JOB NAME:	MALAKOFF HIGH SCHOOLS
JOB NO:	22136
DETAILS OF:	AREA-E CMU WALL REINFORCEMENT DETAILS
DATE:	11-08-22
DETAILER:	SSSTR
DRWG:	M03
TEXAS REBAR, LLC 817-487-1672

JOB NAME: MALAKOFF HIGH SCHOOLS	
JOB NO: 22136	
DETAILS OF: AREA-E CMU WALL REINFORCEMENT DETAILS	DATE: 11-08-22
DETAILER: SSSTR	DRWG: M04
TEXAS REBAR, LLC 817-487-1672

**D ELEVATION**  
 REF: A.4.14, A.5.04, A.5.41 S.3.24, S.3.66  
 SCALE: 1/4" = 1'-0"

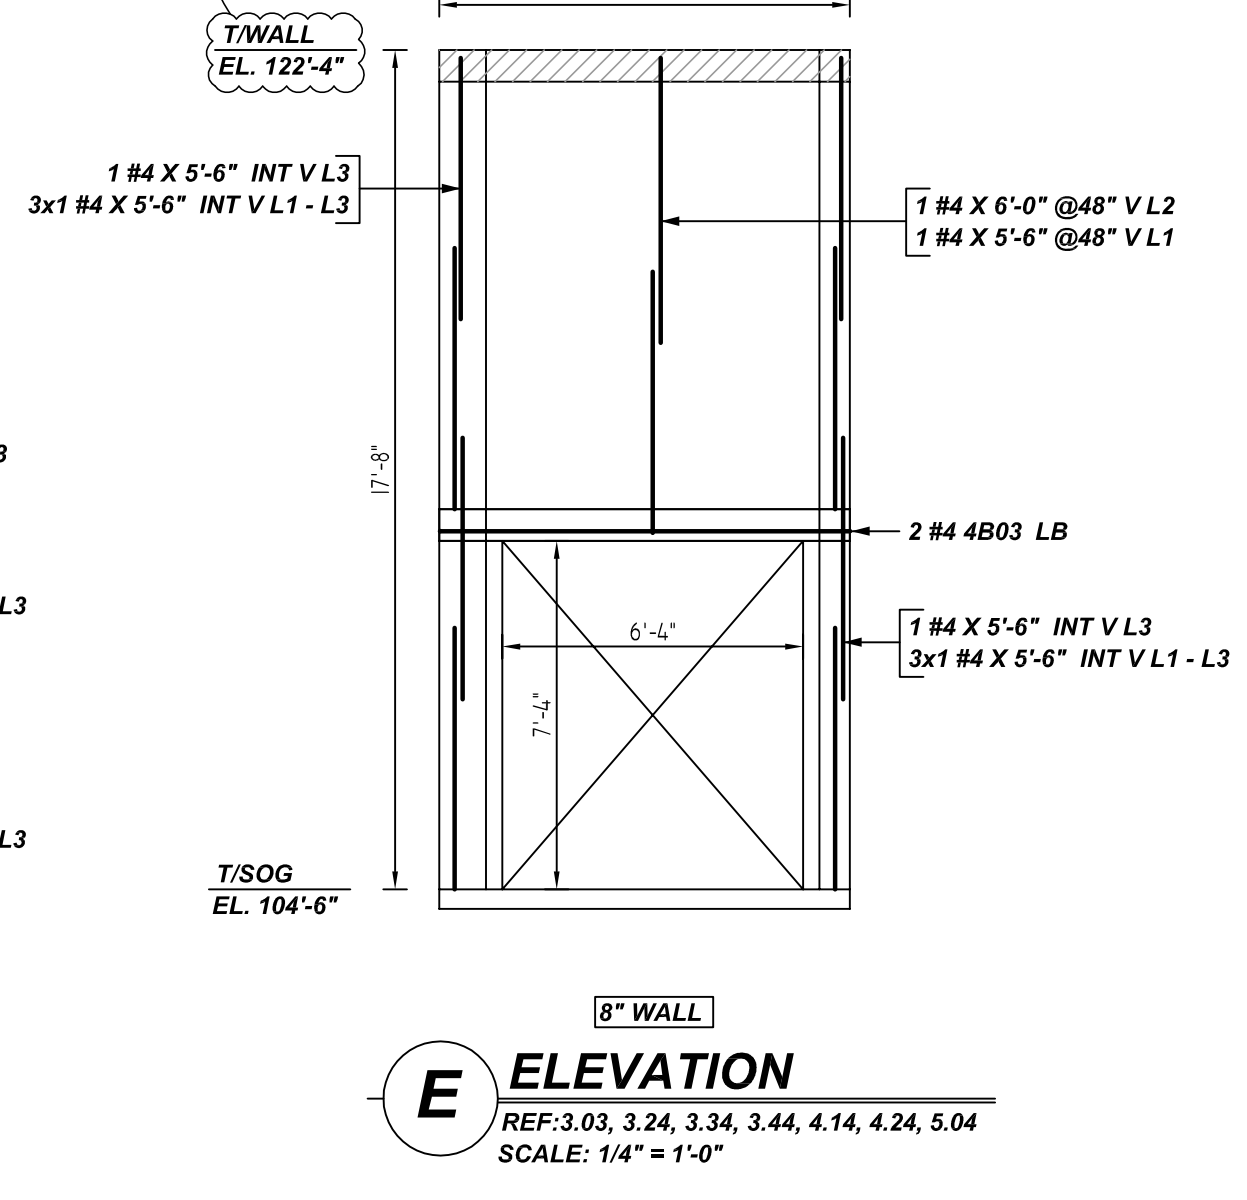
A/E PLEASE VERIFY, THE TOP OF WALL LEVEL WE HAVE PROVIDED

**E ELEVATION**  
 REF: 3.03, 3.24, 3.34, 3.44, 4.14, 4.24, 5.04  
 SCALE: 1/4" = 1'-0"

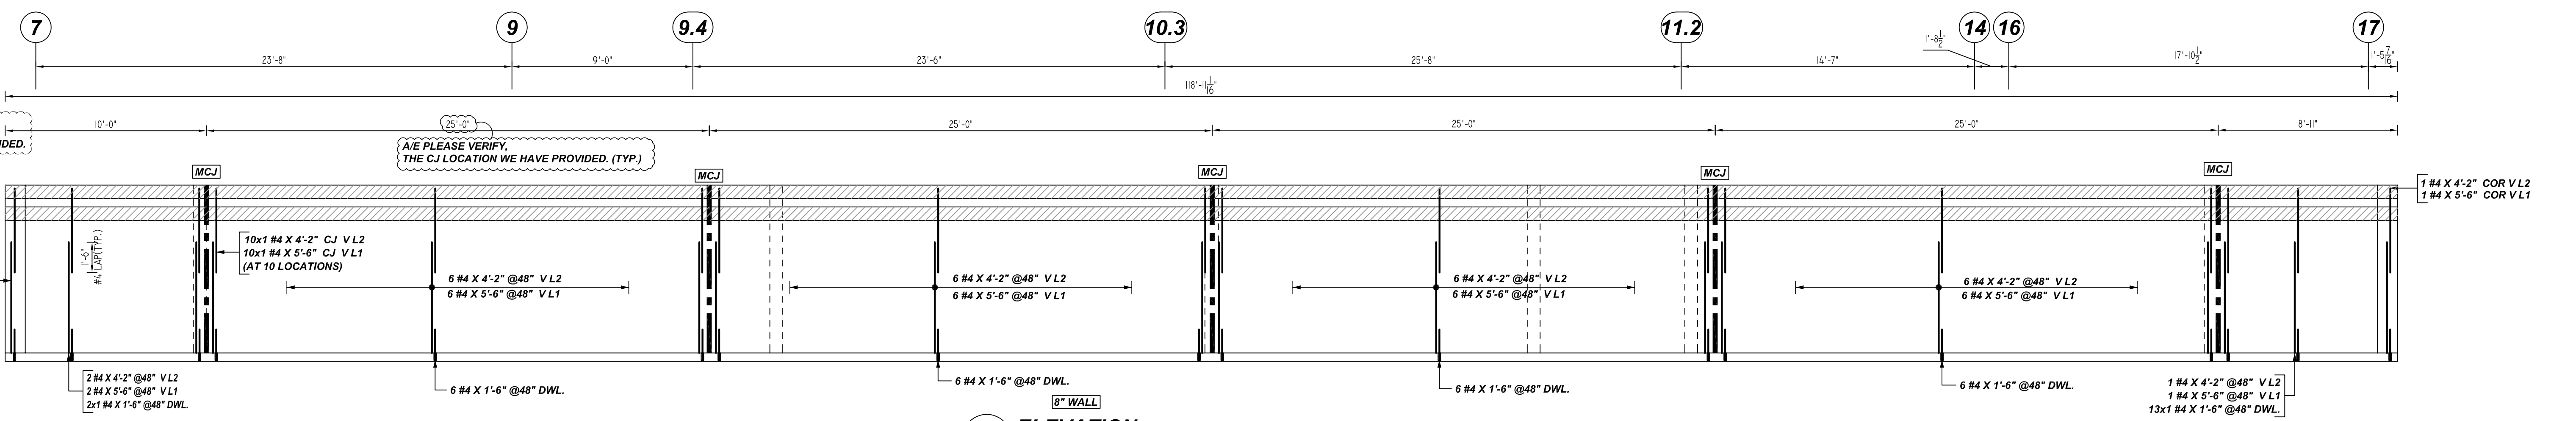
A/E PLEASE VERIFY, THE TOP OF WALL LEVEL ELEVATION WE HAVE PROVIDED.

A/E PLEASE VERIFY, THE CJ LOCATION WE HAVE PROVIDED. (TYP.)
